Project	IEEE 802.16 Broadband Wireless Access Working Group < http://ieee802.org/16 >	
Title	Clarification of CQICH allocation request header	
Date Submitted	2005-03-17	
Source(s)	Yongseok Jin, Bin-Chul Ihm, Jin Young Chun LG Electronics. Inc.	Voice: 82-31-450-7187 Fax: 82-31-450-7129 jayjay@lge.com
	Jung Je Son Samsung Electronics	jungje.son@samsung.com
Re:	This is a contribution to IEEE 802.16e.	
Abstract	In the current document of 802.16e, i.e., 16e/D6, the type field code allocation is problematic, e.g., duplicated allocations. This contribution proposes to add tables to list the type fields encodings and also to clean up the type code allocation problems in 16e/D6.	
Purpose	To correct the errors of the type code allocations and also to improve the type code allocations.	
Notice	This document has been prepared to assist IEEE 802.16. It is offered as a basis for discussion and is not binding on the contributing individual(s) or organization(s). The material in this document is subject to change in form and content after further study. The contributor(s) reserve(s) the right to add, amend or withdraw material contained herein.

Clarification of CQICH allocation header

Figure 20d—CQICH Allocation Bandwidth request

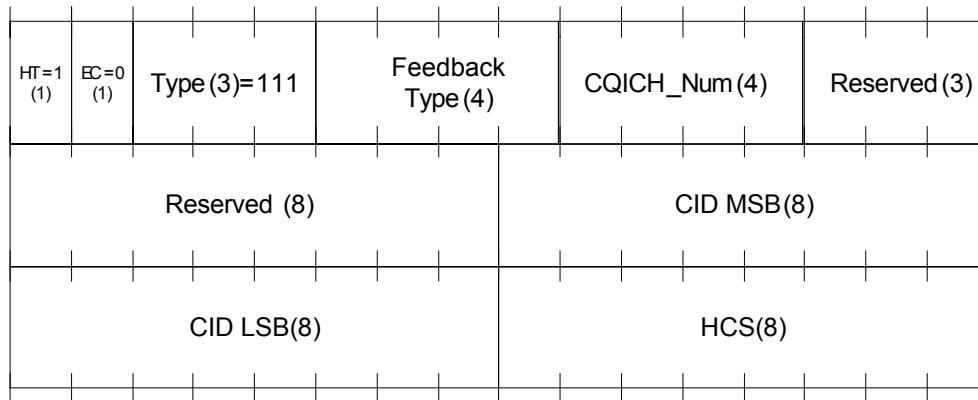
[Insert new sub clause 6.3.2.1.2.3:]

6.3.2.1.2.3 CQICH Allocation Request Header

The CQICH Allocation request PDU shall consist of CQICH Allocation request header alone and shall not contain a payload. The CQICH Allocation request header is illustrated in Figure 20d
